Yuhuan Getal Machinery Co., Ltd		
PART No 零件名	FS6801-L-06-08-NW□	
SCALE:	APPD: 批准 Zhang	DRN: 制图 Sun Jiahuan 2017.06.23
NTS	DATE: 日期 2017.06.23	CHK: 审核 LI JunBao 2017.06.23

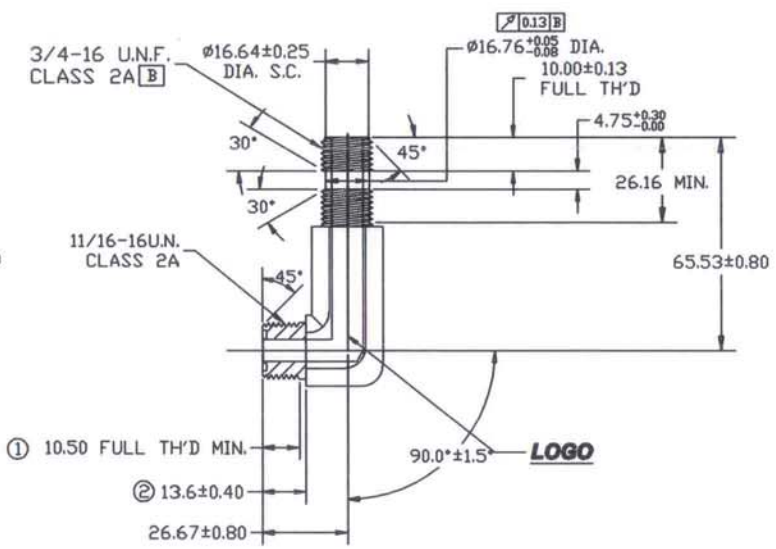
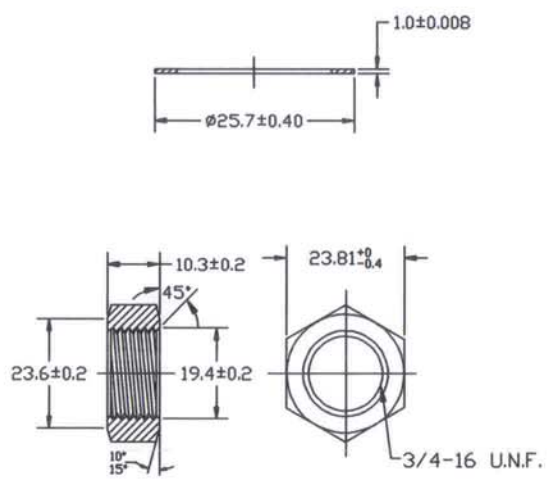
REV 更改号	DATE 日期	REVISION DETAILS 更改内容	APPD 审核并批准
①	Jun.2,2017	Delete the thread undercut and change Dim.8.13 to 10.50 and Dim.11.2 to 13.6	
②
